OAKRIDGE VILLAGE SUBDIVISION
PRELIMINARY OVERALL AREA
DEVELOPMENT PLAN

INFORMATION SHEET FOR
PRELIMINARY OVERALL AREA DEVELOPMENT PLAN
(P.O.A.D.P.)

Re: Oakridge Valley ☐ Preliminary Plan
File #: 83-10-61-80 ☒ P.O.A.D.P. (Revision dated 10-9-84)
10-9-84

Re: Oakridge Village

**OAKRIDGE VILLAGE SUBDIVISION
PRELIMINARY OVERALL AREA
DEVELOPMENT PLAN**

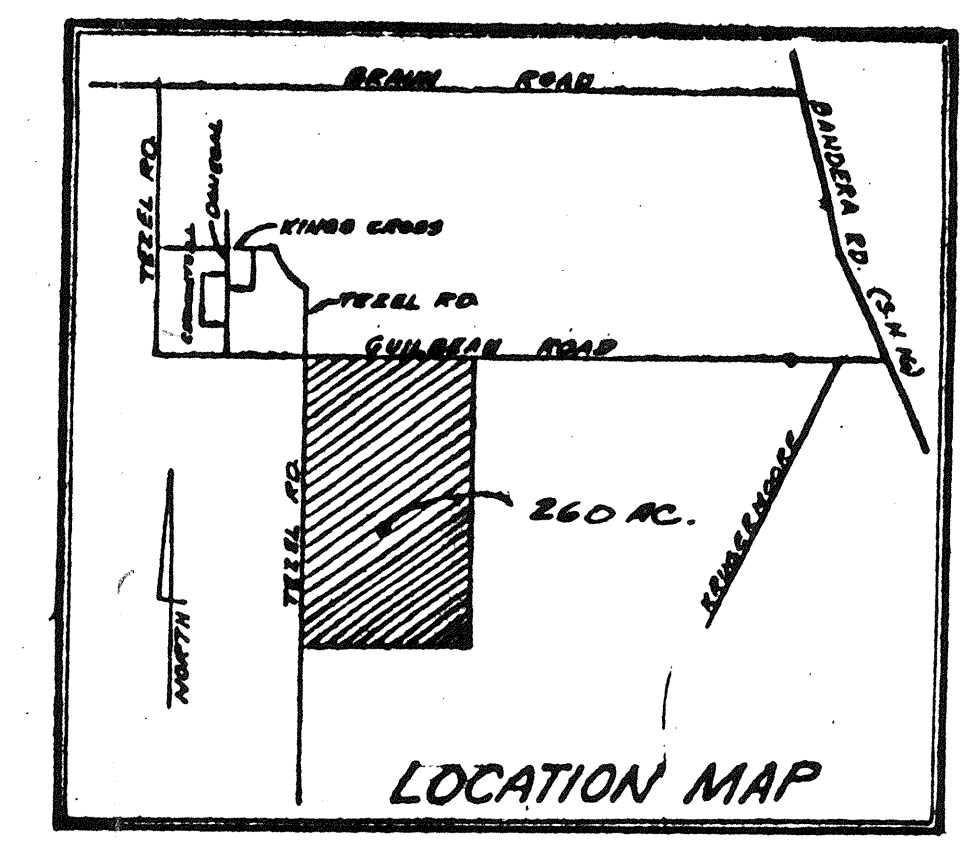
**REVISED P.O.A.D.P. REFLECTS
CHANGE IN CONFIGURATION IN
UNIT 4, 5 & 7 & N. FORK ST. WITH
WITH OAKRIDGE VILLAGE**

8-29-83
need additional copy of info.
not will show all existing streets, know ownership
know adjacent proposed development & proposed
street width.
10-18-84 staff reviewed revised P.O.A.D.P. dated 10-9-84 no sig was impact

- () is in general compliance with the Subdivision Regulations
- () lacks compliance with the Subdivision Regulations regarding:
 - () Street layout
 - () Relation to adjoining street system
 - () Stub streets
 - () Street jogs or intersections
 - () Dead-end streets
 - () Cul-de-sac streets in excess of 500'
 - () Low density lots fronting onto major thoroughfares
 - () 24' alley(s)
 - () _____
 - () _____
 - () _____
- () See annotations/comments on attached copy of your plan.
- (X) Comments: This acknowledges receipt of the revised plan reflecting a new subdivision layout for certain areas. Staff offers no objections. However, staff comments dated 9-14-83 are still applicable.

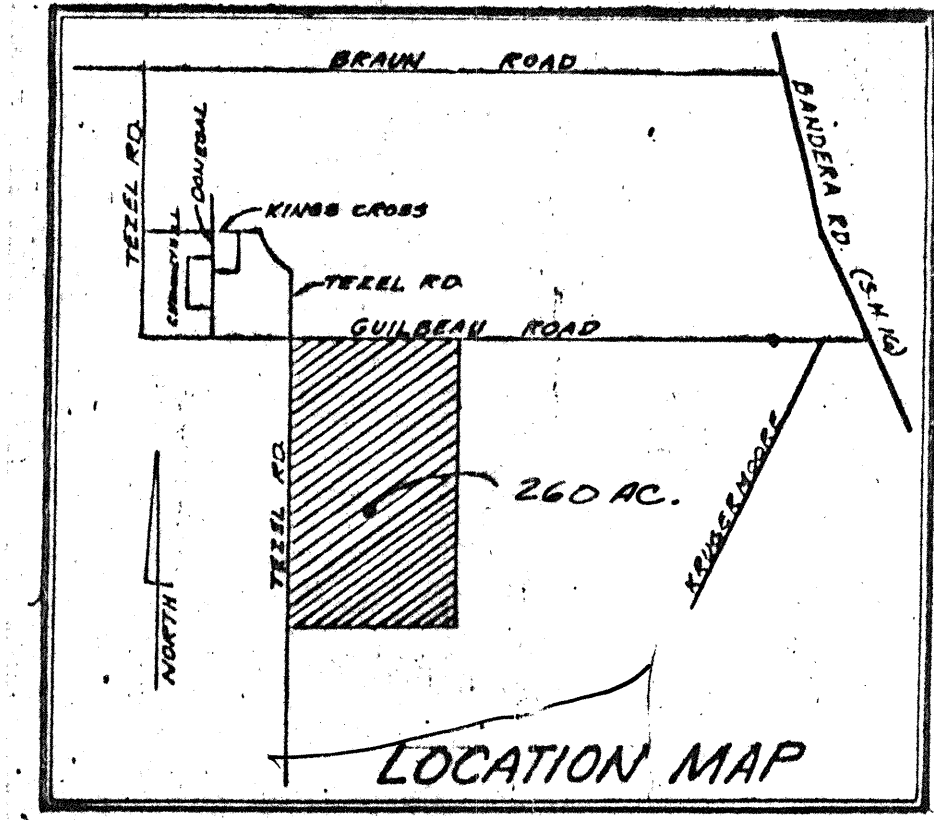
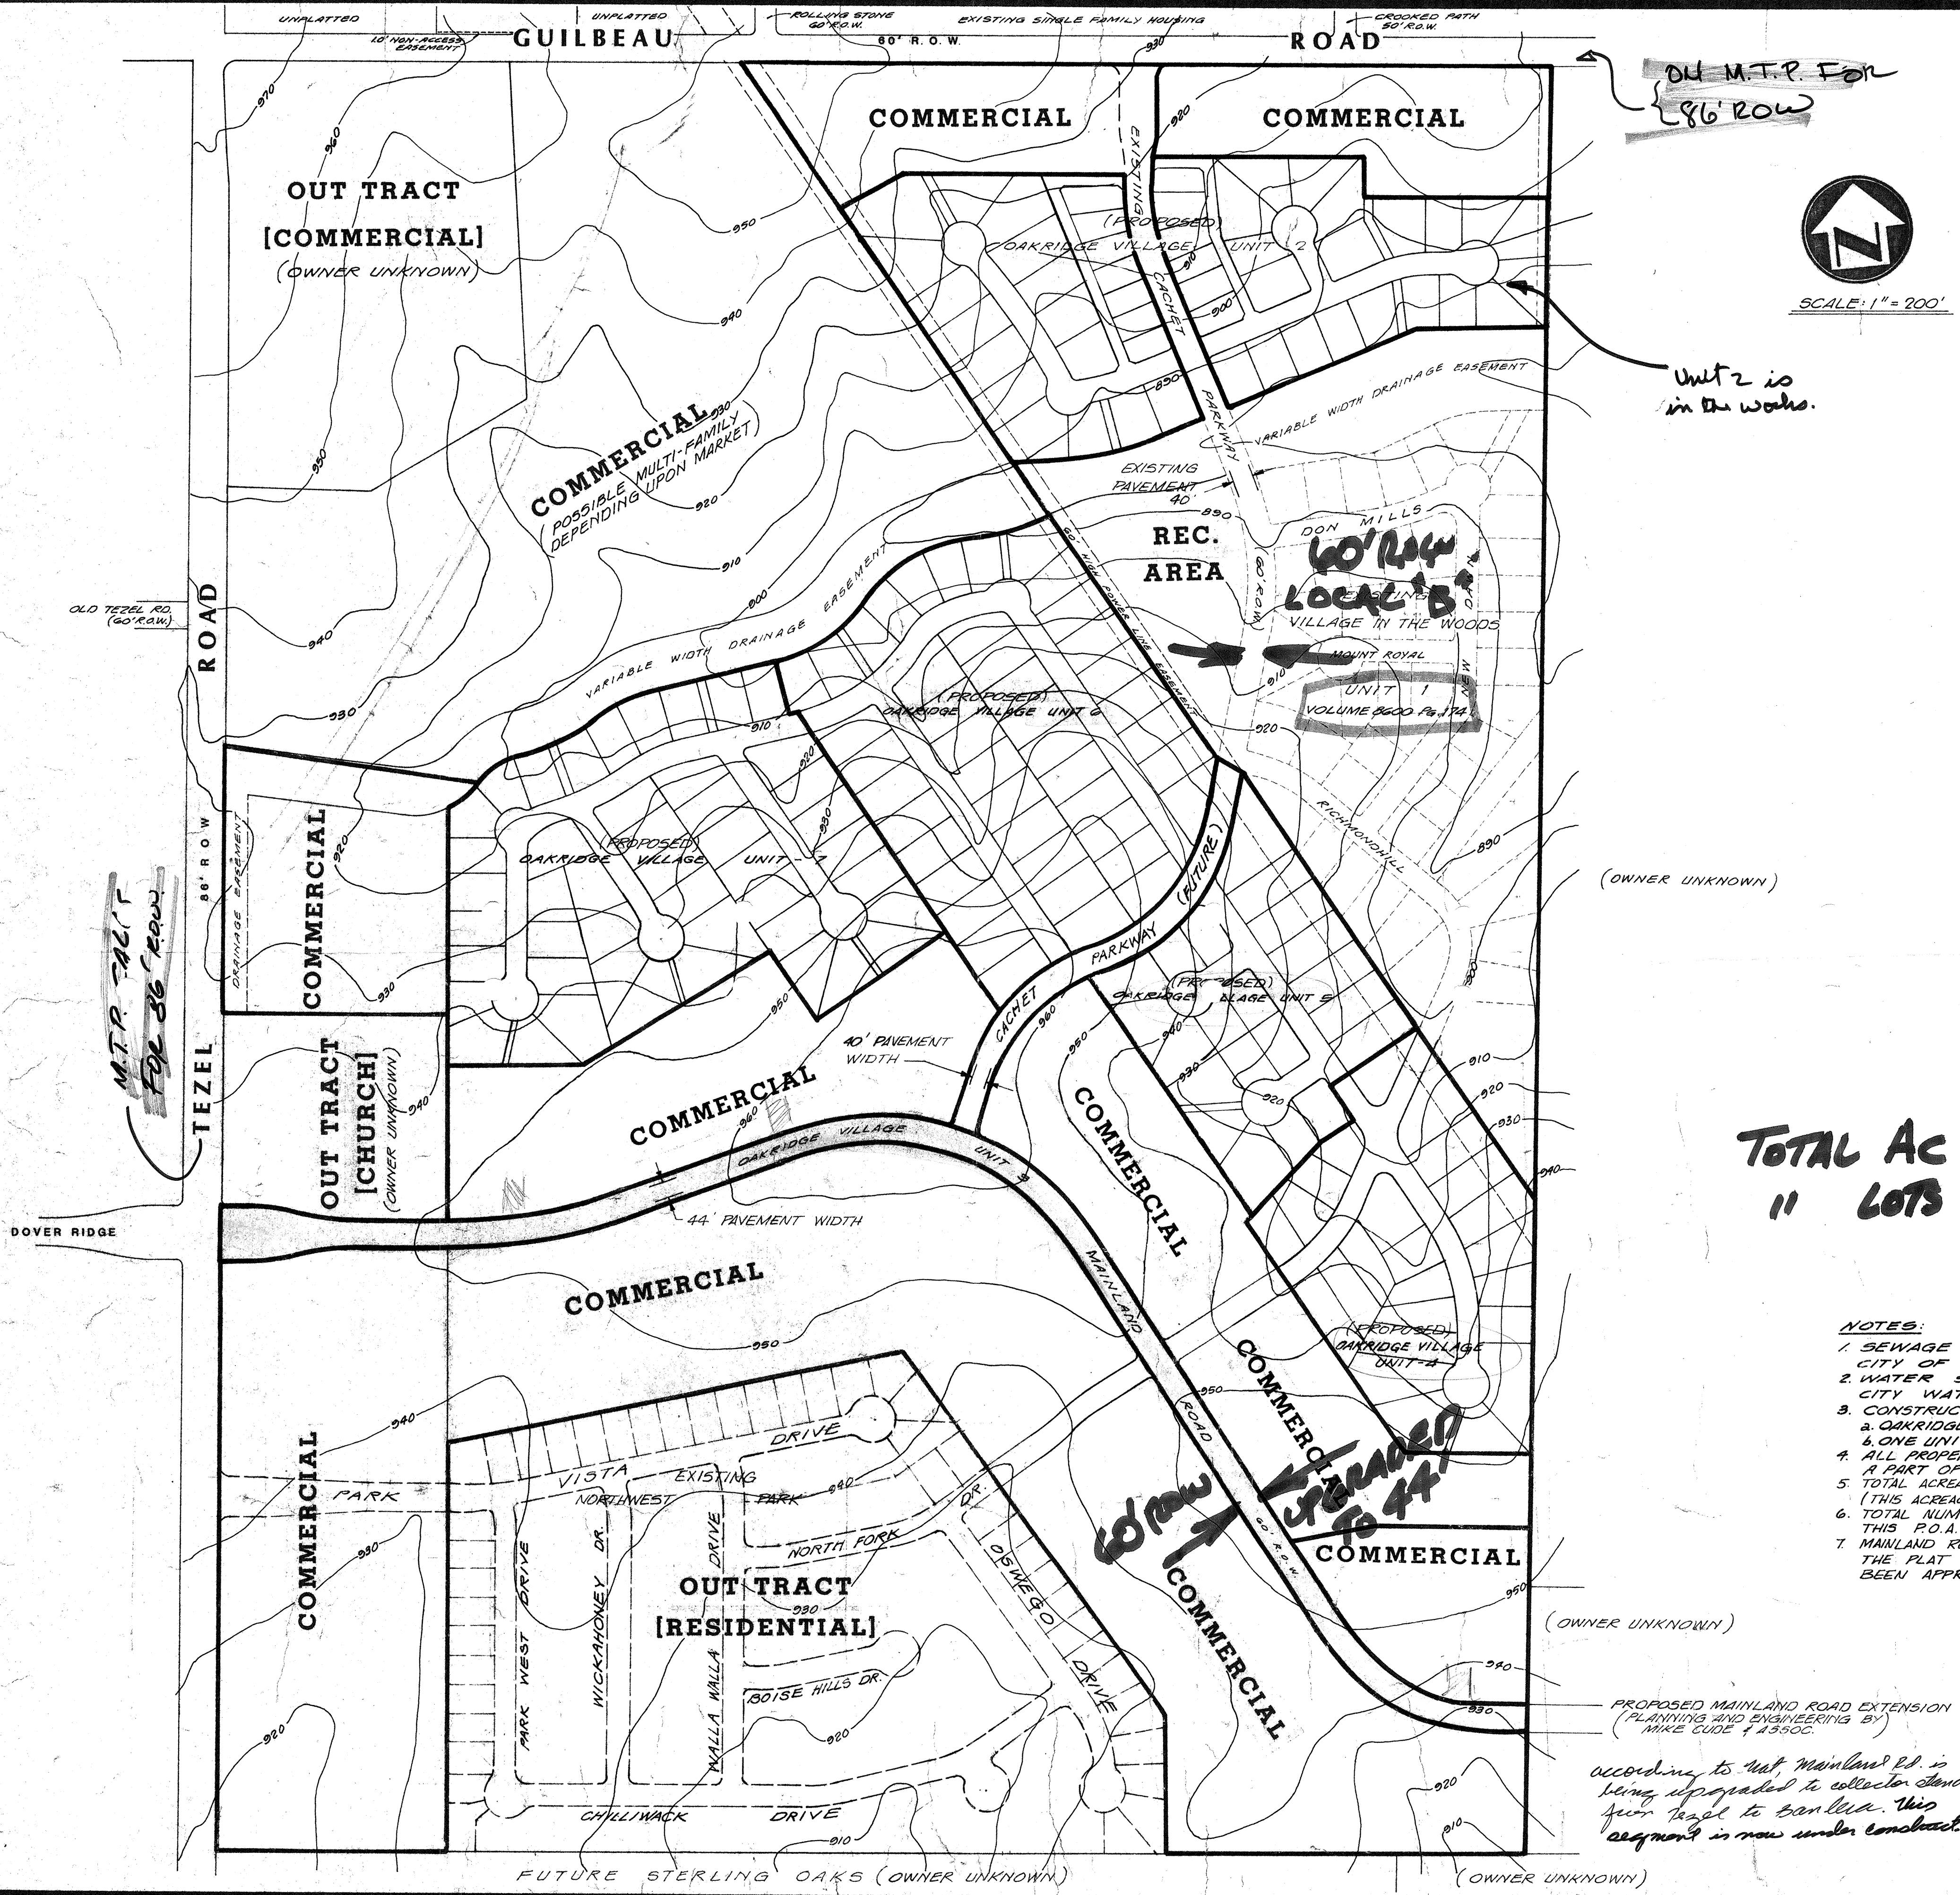
REVISED POADP reflect
13' Dcd along Guadalupe Rd.
* & Proposed street name change

2-21-85 committee reviewed and consensus was to make an effort to get all the property owners along the southern edge of Guilbeau together to discuss ded. needs. Staff will ask for 26' for the future widening of Guilbeau Rd. which will talk to Bally about this & set up meeting.

Held 2-11-85 meeting with respective property owners along the southern edge of Guilbeau Rd. Ellison, San Parnes, Earl Hardy, Ed Mary. of David Breen Land Development. The meeting was to get a feel for whether property owners were receptive to dedicating 26' to accommodate 8' widening. Some expressed interest, however, there was not a full consensus. As result will write letter to each owner to formally request the ded. Based the response staff have direction on dropping or pursuing idea.
